January 23, 2025  
147507131

**RE: *Modifications to Site Plan Application***  
***Subject: Final Site Plan Review for a commercial building of approximately 120,000 sq. ft. and associated parking areas in a Planned Development (PD) Zoning District within the Oakwood Activity Center.***  
***File No: 24-DP-31***

**OAKWOOD PLAZA SOUTH  
RETAIL SHOPPING CENTER  
PLANNING RATIONALE REPORT  
JANUARY 2025  
CITY FILE NUMBER 24-DP-31**

The following images compare elevations that were submitted previously with the updated design.

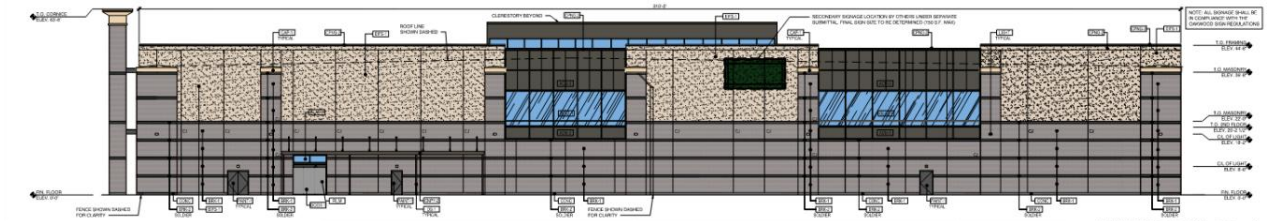
1. The overall store front elevation has been revised to include more glazing, which reduces the amount of wall surface that was previously proposed:
  - a. The windows on either side of the entrance have expanded by approximately 48 linear feet (20% of the frontage) to incorporate more glazing as requested.

- b. The northeast corner of the building now includes visual access to the climbing wall feature. Instead of housing the climbing wall within the store interior, the climbing wall feature was relocated to the northeast corner; glazing was also added to showcase the wall and provide more interest to that important corner of the building. The increased glazing provides more daylight into the store, along with activating the corner by increasing the visual interest of this community benefit and retail store feature.

- c. The northwest corner of the building has incorporated more glazing as well. This again allows more light to enter the store and visually activate the space.

- d. The west elevation has an enhanced design bringing the building and the field into better harmony than was previously presented.
2. At the suggestion of the Planning and Development Board, we have added benches and bike racks along the front of the building to provide a place to sit and park your bike while in the store.
